# Staff Report

**To:** Salt Lake City Planning Commission  
**From:** Cassie Younger, Senior Planner, [cassie.younger@slcgov.com](mailto:cassie.younger@slcgov.com)  
Meagan Booth, Principal Planner, [Meagan.booth@slcgov.com](mailto:Meagan.booth@slcgov.com)  
**Date:** March 29, 2023  
**Re:** PLNPCM20222- 01154

## Planned Development Request

**PROPERTY ADDRESS:** 1512 S 300 W & 309 W 1500 S  
**PARCEL ID:** 15-13-206-008-0000 & 15-13-206-005-0000  
**MASTER PLAN:** Ballpark Area Master Plan  
**ZONING DISTRICT:** CG – General Commercial

LANDSCAPE PLAN

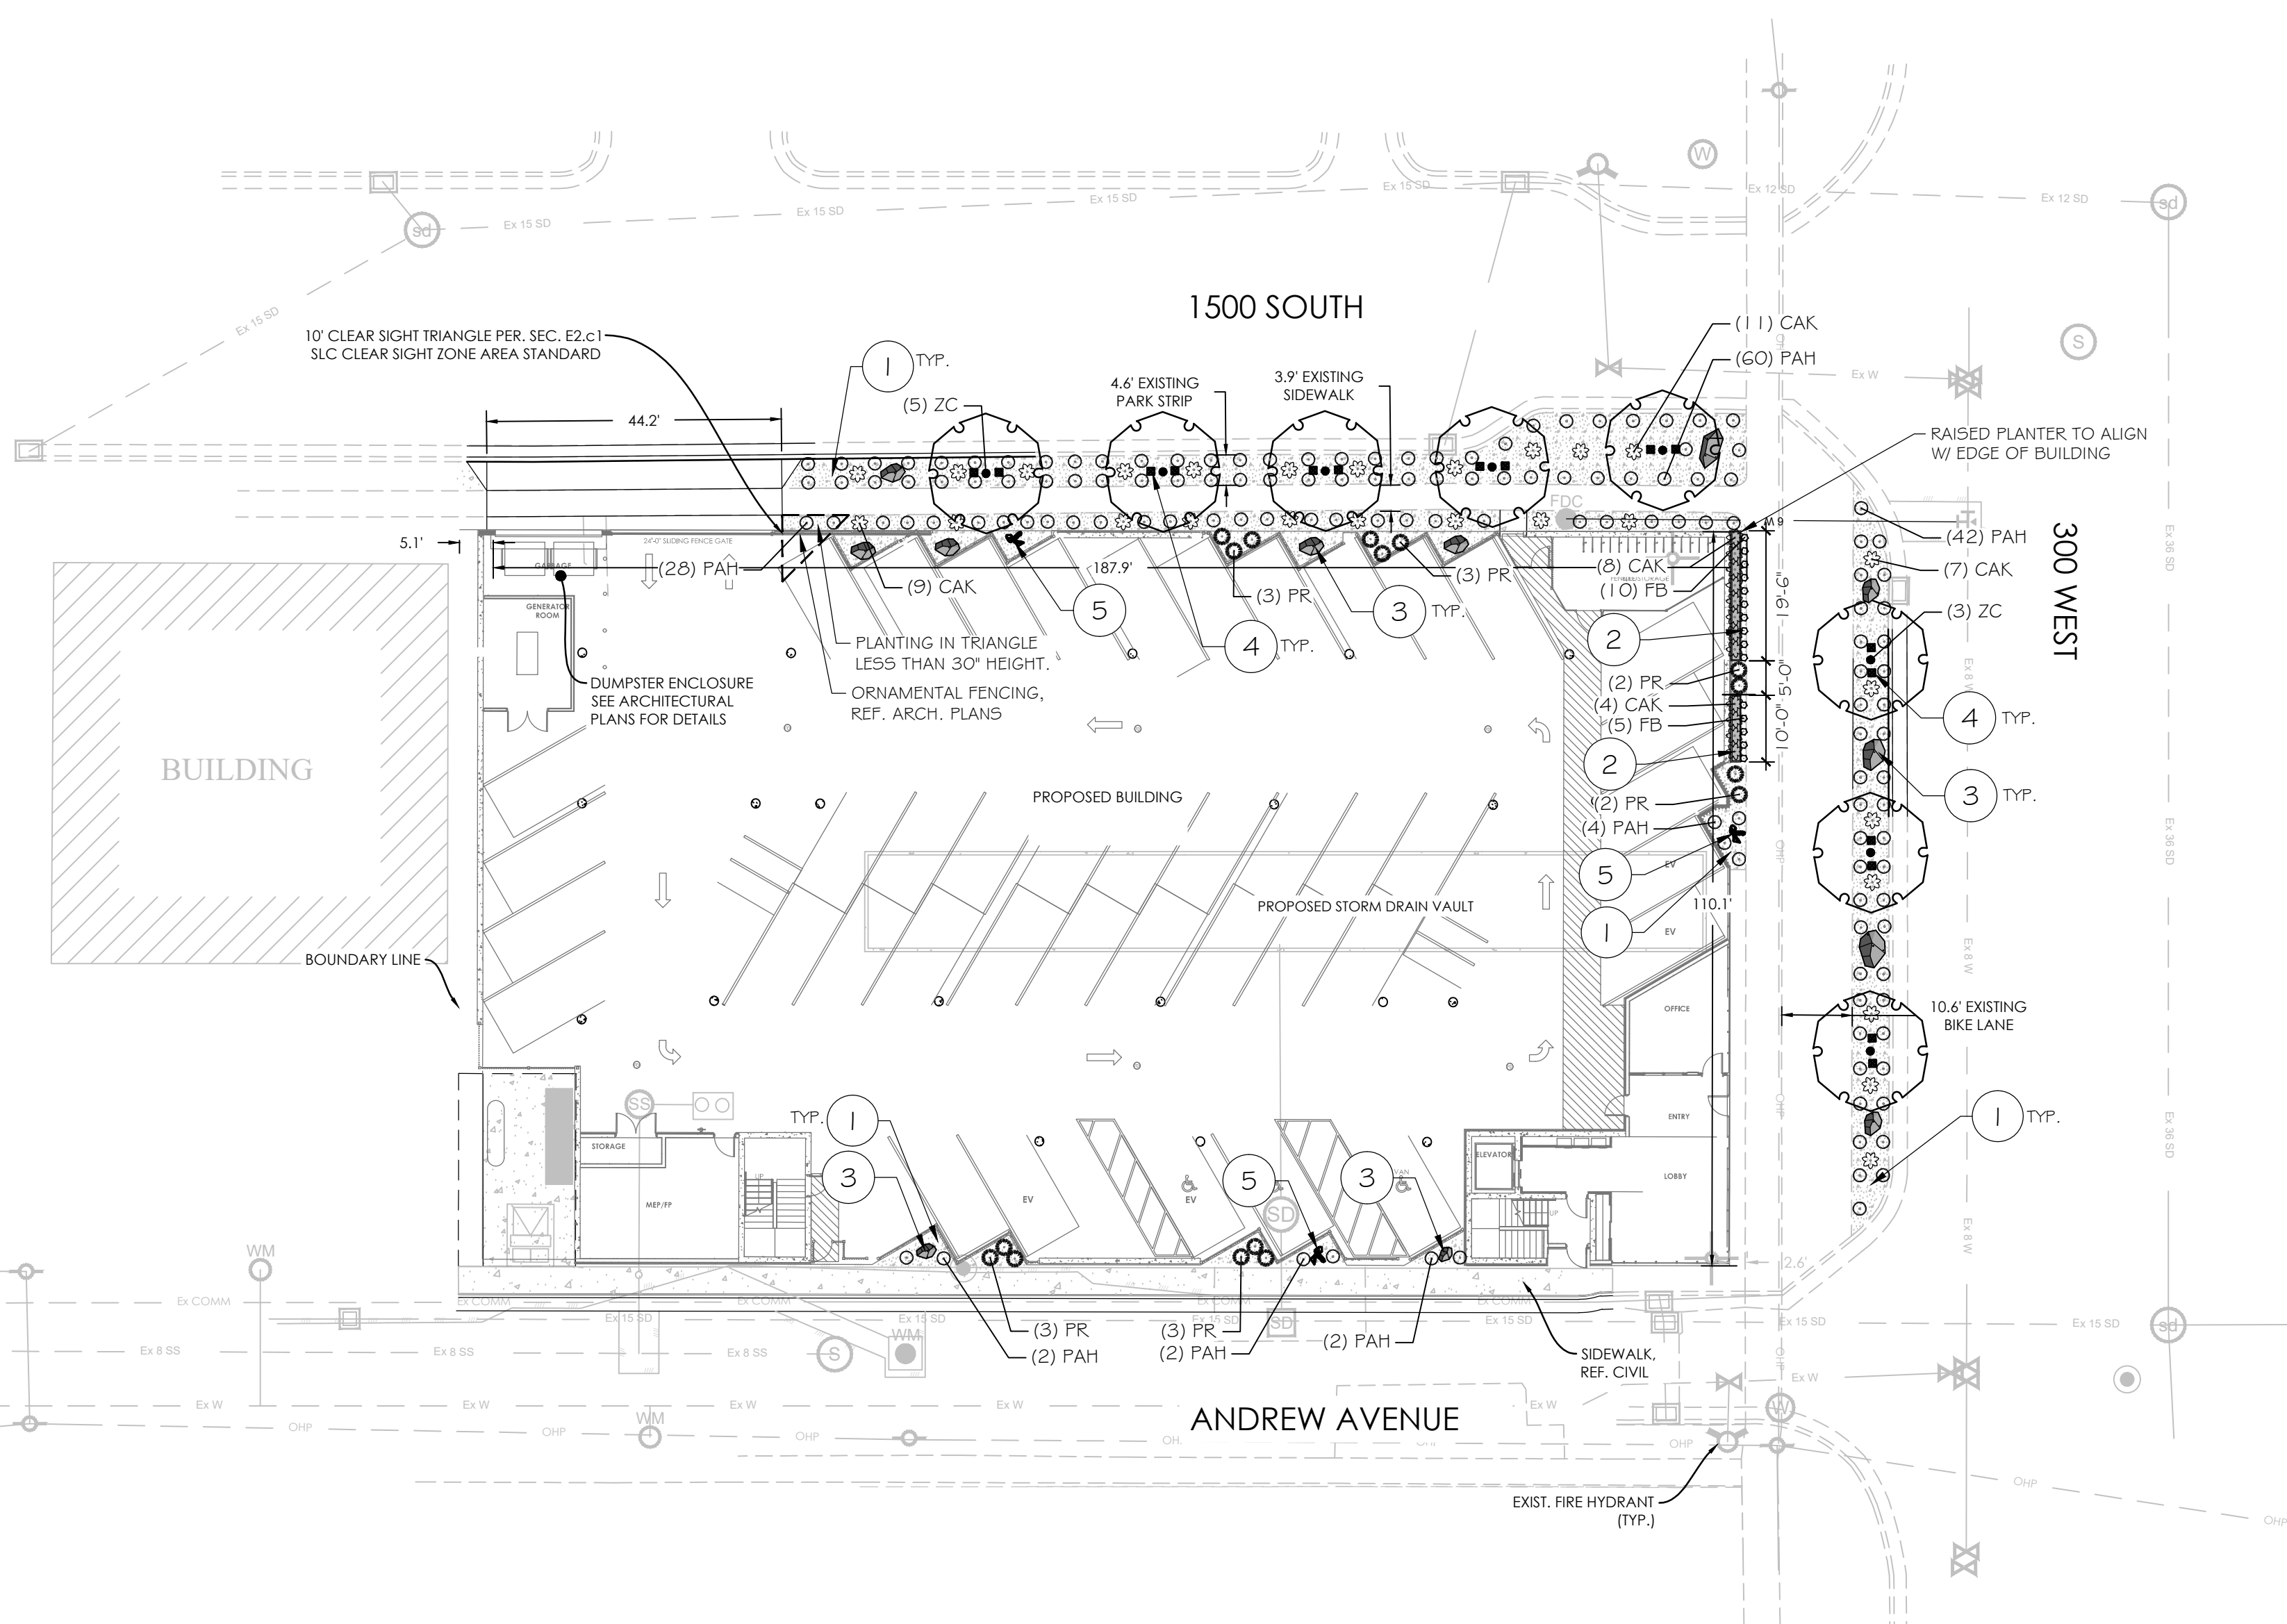
I was on site yesterday. There are no trees installed on 300 W adjacent to this site, though there is a parkstrip available to plant trees in. The species used along 300 W are Honeylocust. The 300 W rebuild project has planted the trees on the west side of the street for the whole length of the project except a short section in this area. I don't know why not in this area. Urban Forestry is less concerned with the specific species chosen, but more concerned about the mature size of the tree being appropriate for the space provided and that the one tree every 30' of street frontage code be fulfilled.

If there were trees put in with the project they should be protected in place. The 300 W construction plans are not clear on what trees should have been planted there because there was initially a crosswalk planned in front of this property and it was moved further south. If trees have been planted with the project they are either the responsibility of Urban Forestry now, or will be as soon as the 300 W project in this area wraps up. I recommend asking the applicant to confirm what trees are existing on site and providing a protection plan if there are trees now there (I didn't notice if there was one on file with their demo permit). If there are no trees I recommend that the trees planted match the trees planted along 300 W with the project. I think they were Zelcova's, but not sure what type. I'm waiting for a response from the project manager on the type and can let you know when I hear back. As for the rest of the landscaping, this area does not have a drainage swale as some other sections of the project do so the proposed landscaping should be ok. But if the landscaping for the project hasn't been installed yet maybe you could just allow them to let the project do their landscaping so the whole street matches.

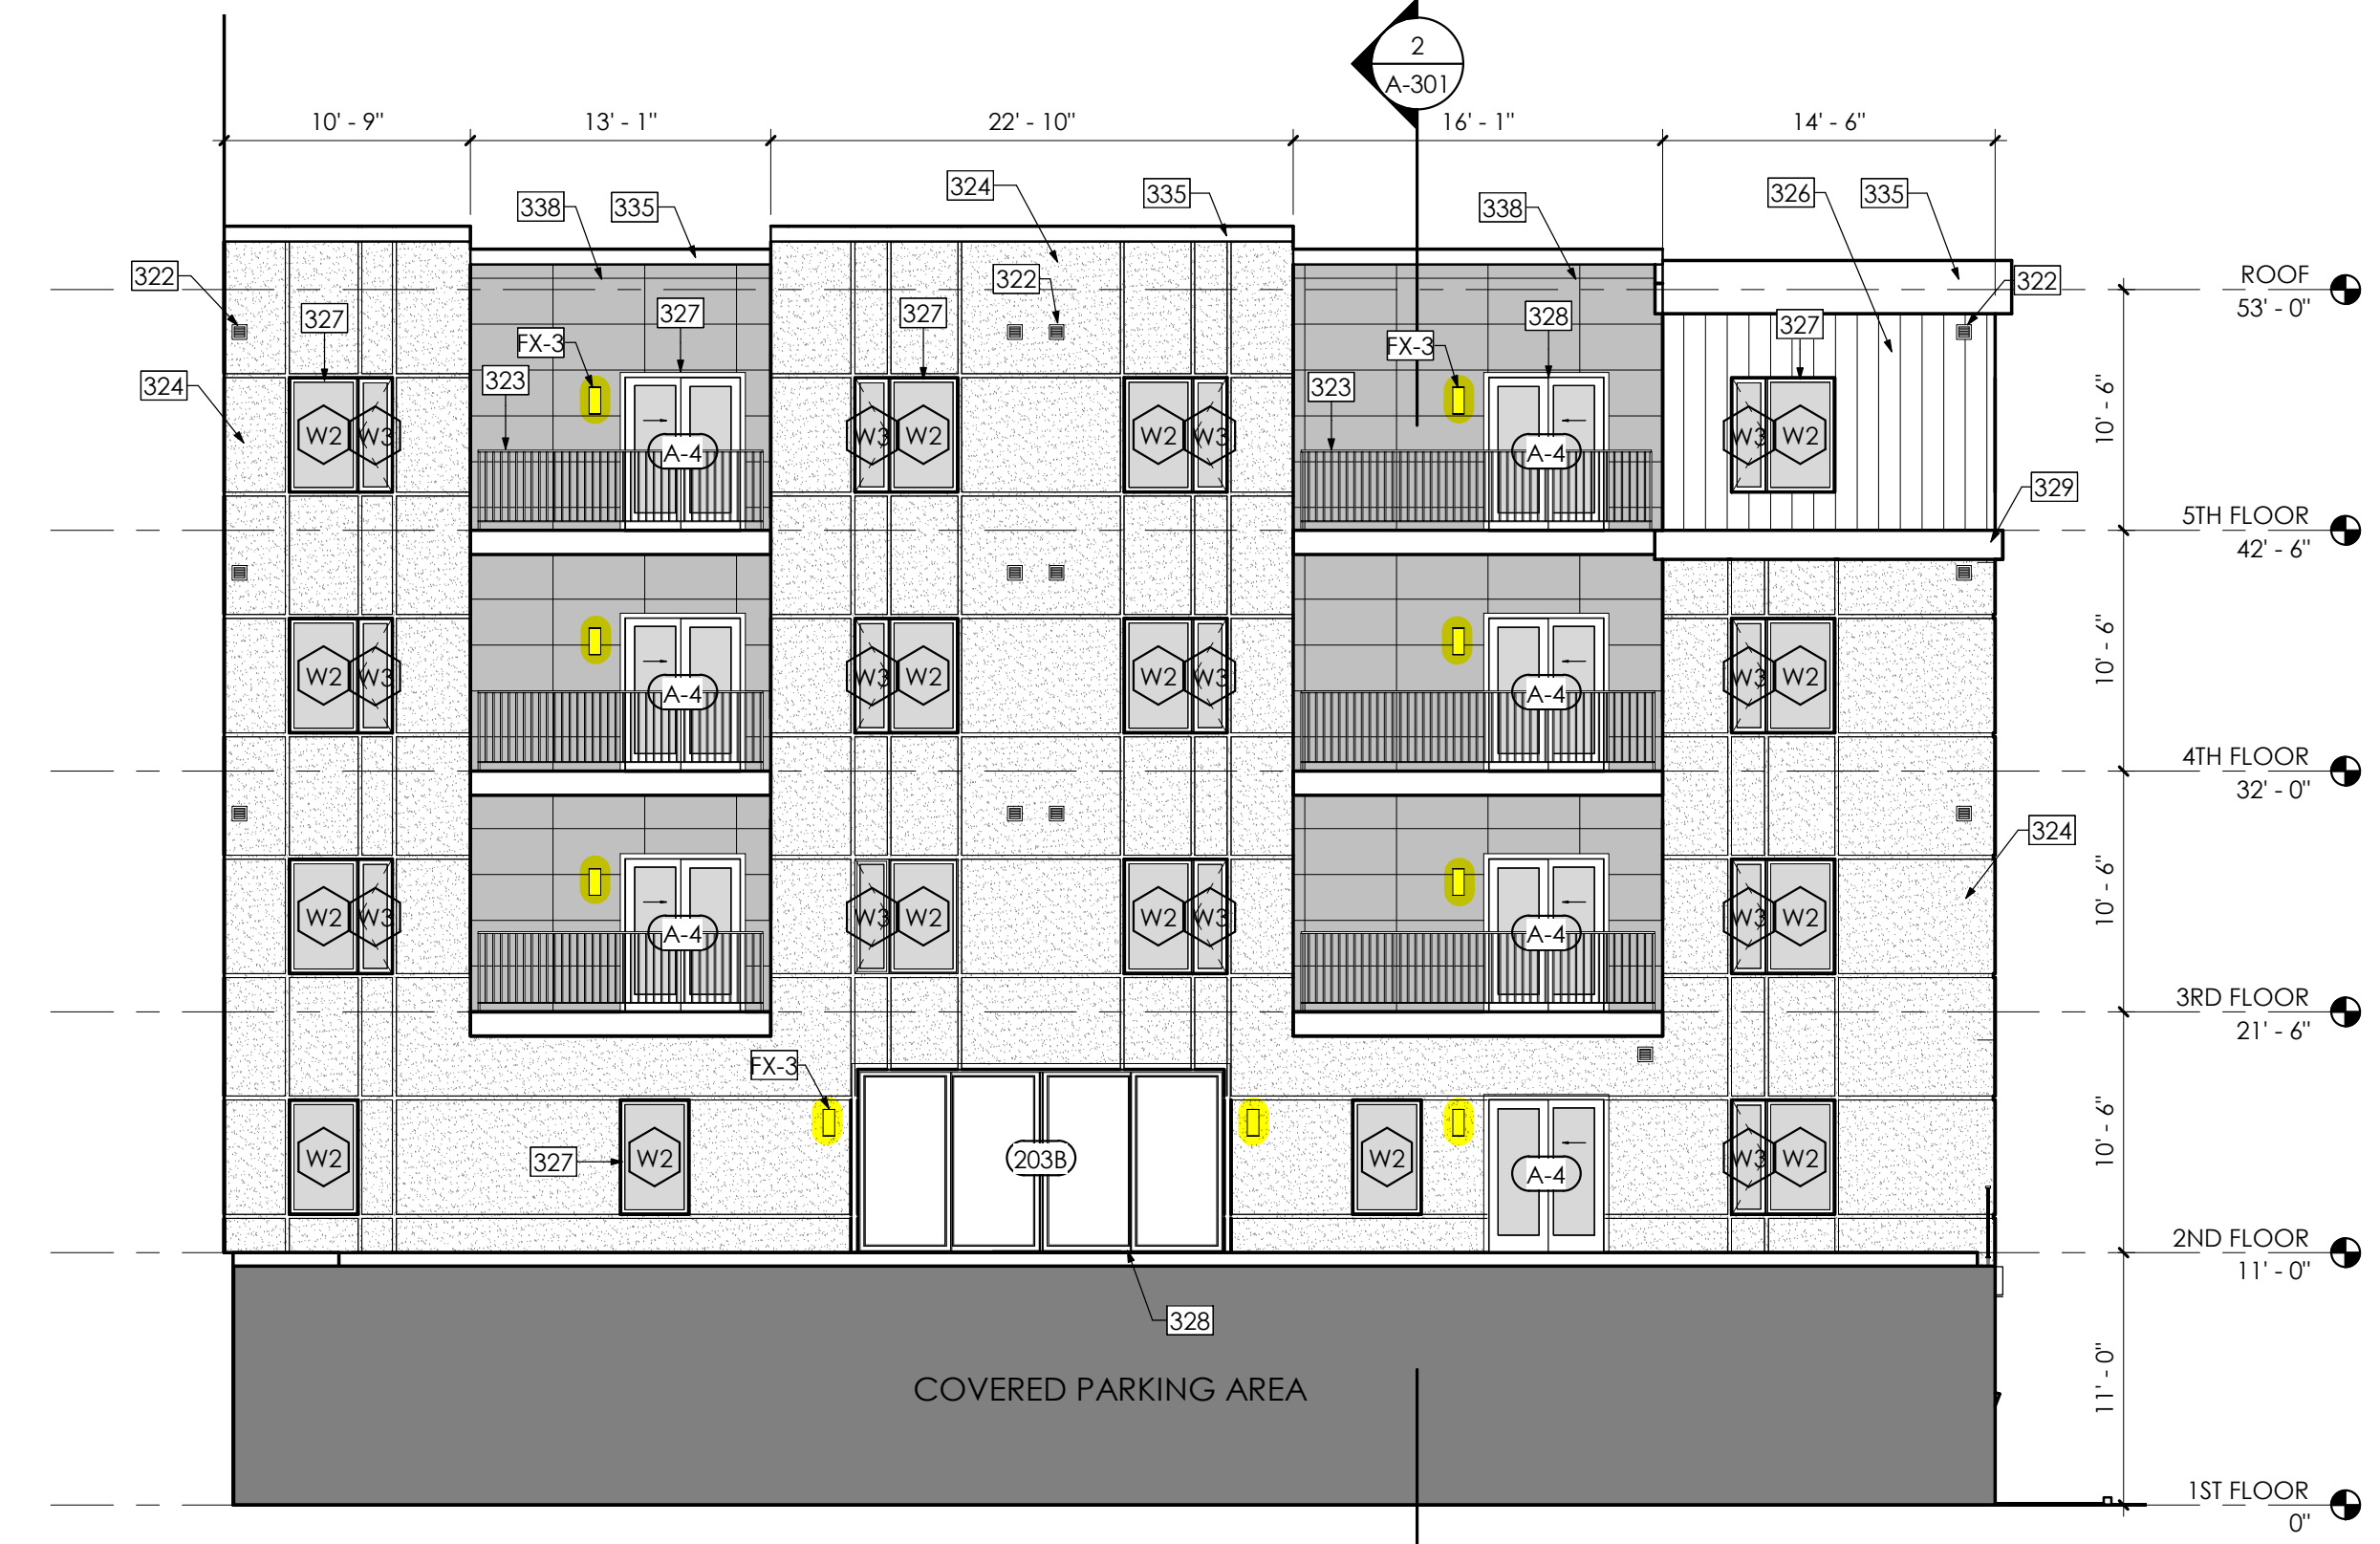
I have looked at the provided plans. I have no problems with the exterior lighting plan. The exterior seems pretty secure and the landscape plan wont interfere with security as those areas have provided extra lighting. I did not see an interior lighting plan for the garage, but I don't have many concerns as it is a secured parking area. Just want to make sure they have sufficient lighting for the security of the residents. There is no main level window access so I wouldn't recommend
